Reference: Gunnedah Solar Farm Draft Water Management Plan (WMP) – Phase 2 – Response to Comments – Reference Number V17/8273#4

**Gunnedah Solar Farm – Water Management Plan
Post Approval Review**

Document: Water Management Plan

Attachment: Gunnedah Solar Farm – Water Management Plan Post Approval Review
Figure from Appendix H – Fencing 1% AEP

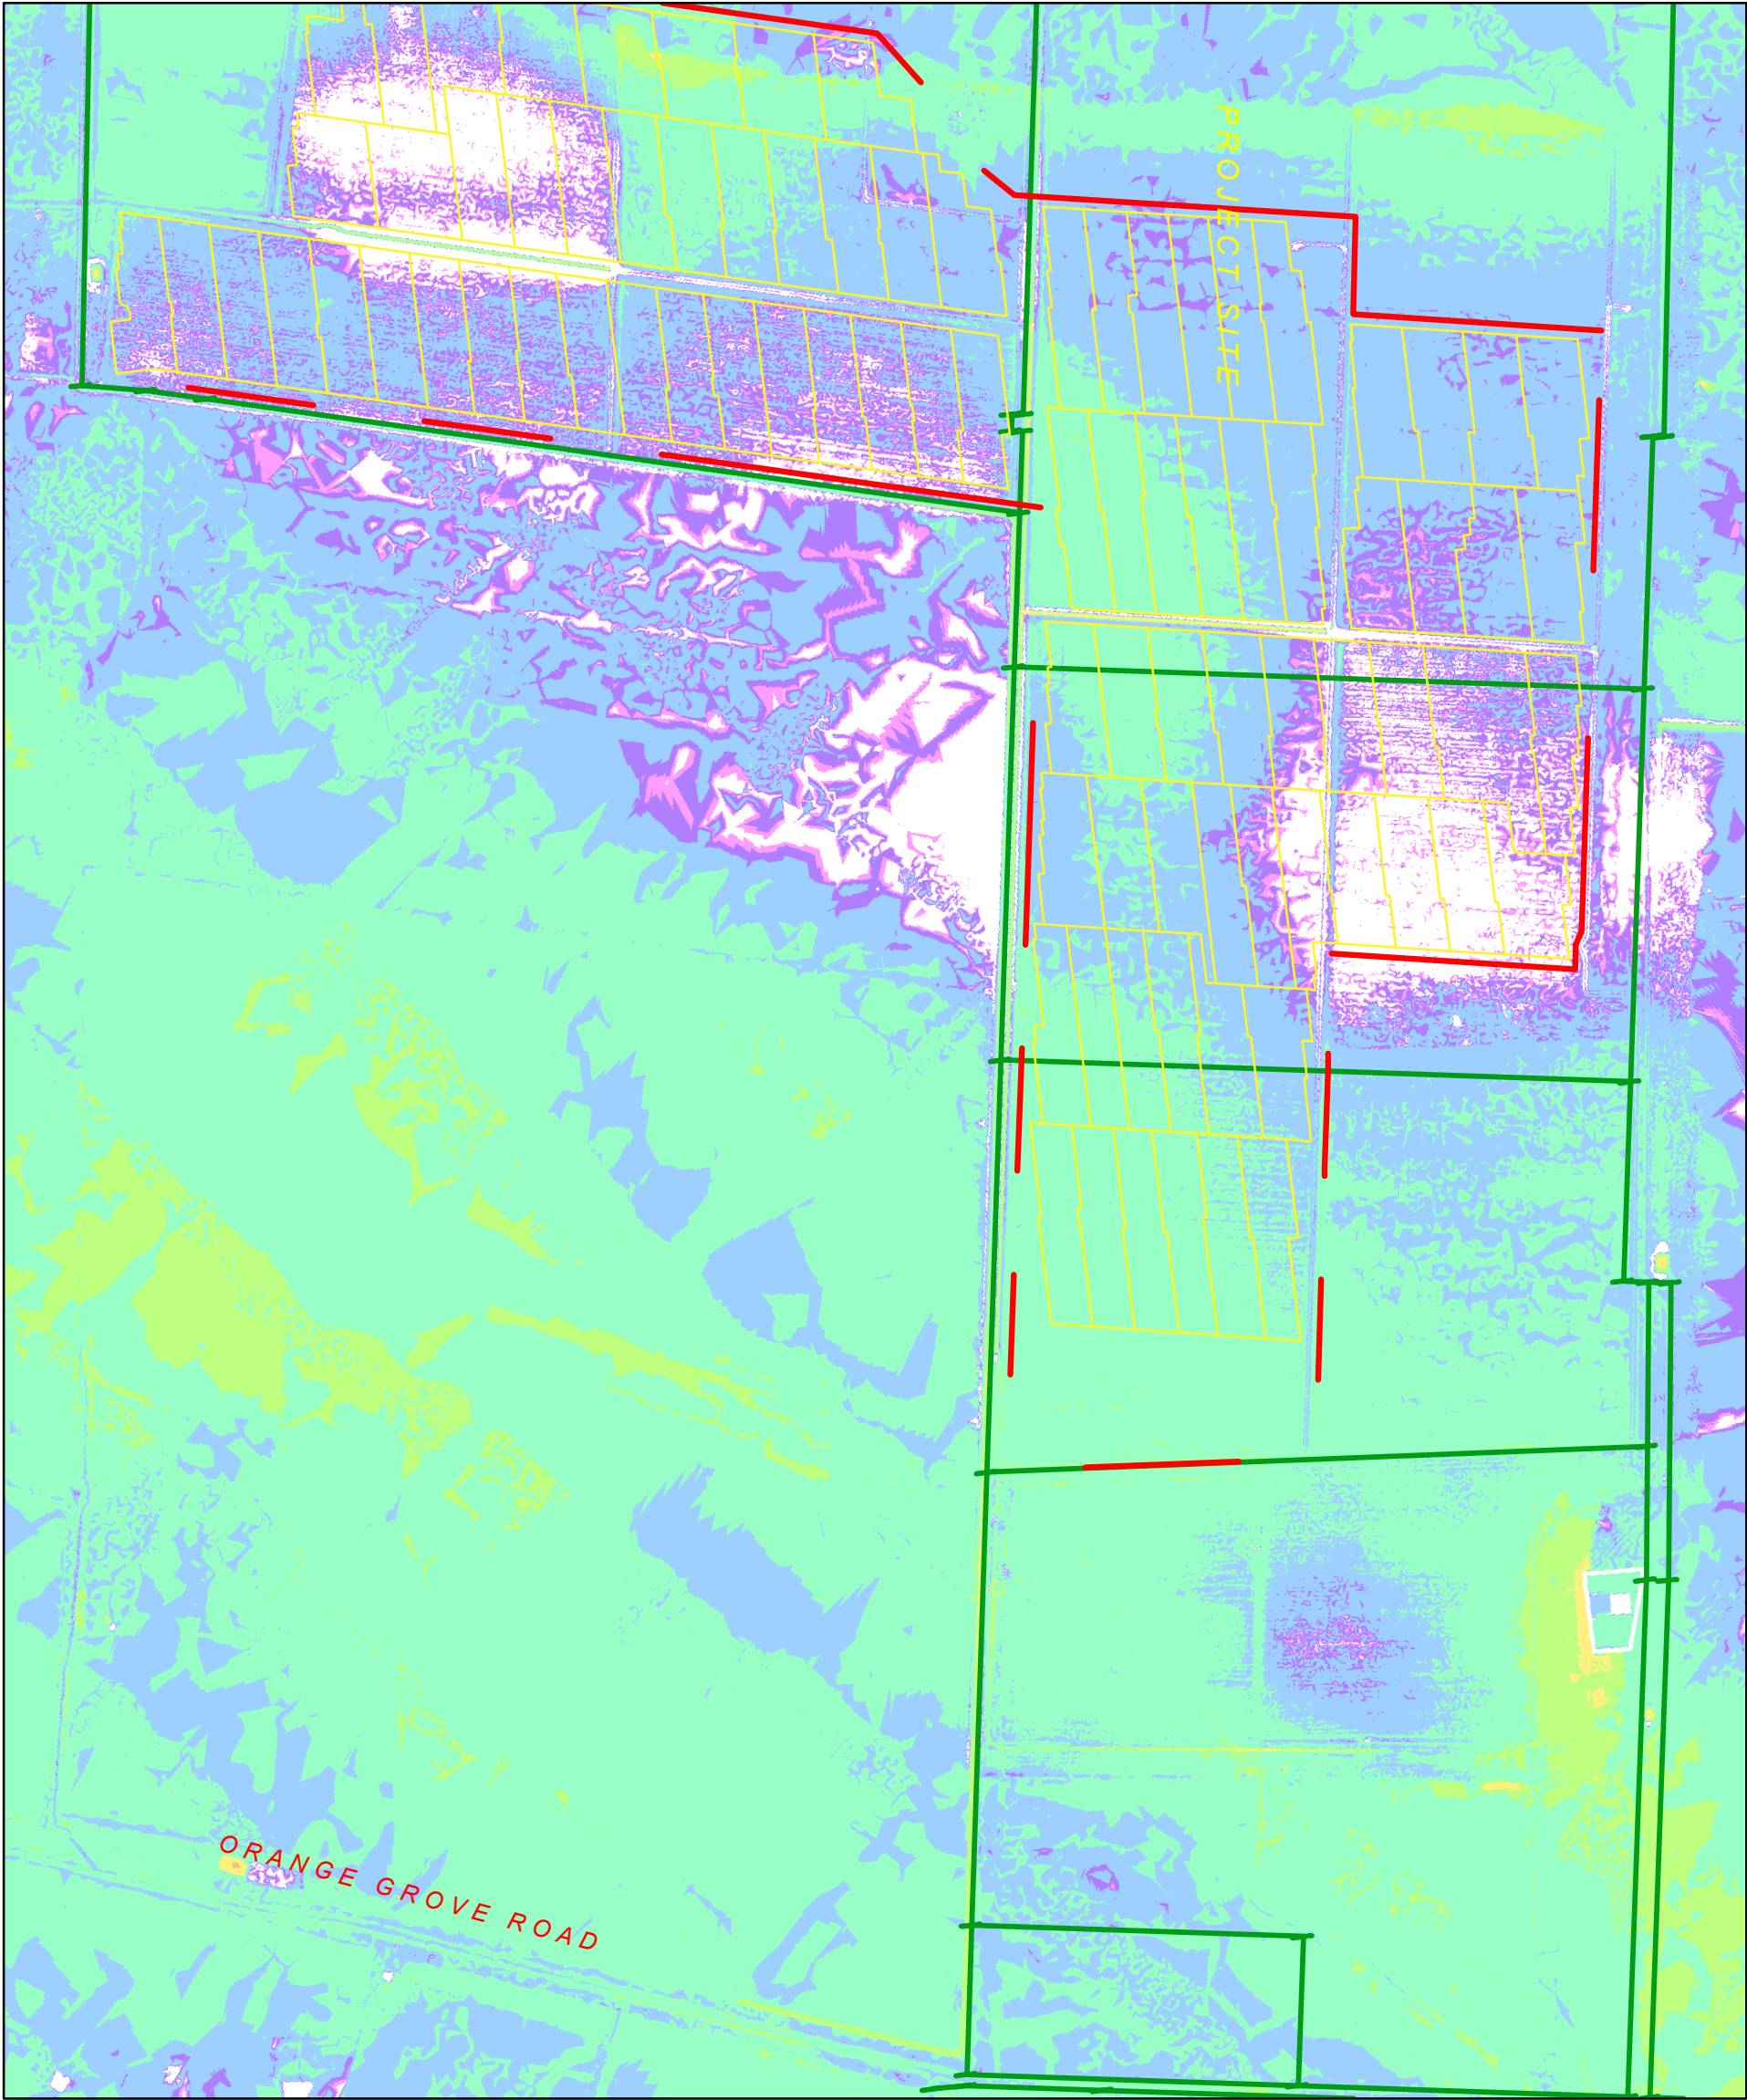
Further detail is required about what would happen in the event of fence monitoring in flood conditions showing a build-up of debris leading to increased upstream flooding? Are there actions that could be undertaken to relieve the build-up if due to the fence?

In the unlikely scenario of the sets of flow through fences not opening up due to build up of debris and hydrostatic forces of the flood waters, there could be a slight afflux increase in the upstream area, but this increase in afflux will likely occur inside the lease boundary causing no impact to owners of neighboring properties.

As shown on the attached figure, there is sufficient buffer between the fence and the lease boundary. In particular where the depth of flooding and discharge is higher as shown in Appendix H.

It is noted that during a significant flood event, site access will be limited due to the inundation of Orange Grove Road and mitigation of buildup along the fence during the event will be difficult. In order to mitigate these concerns, a monitoring program was proposed within the Water Management Plan, including routine inspections and inspections following significant storm / flooding events, to ensure that flow paths are clear of debris prior to the occurrence of a flood event.
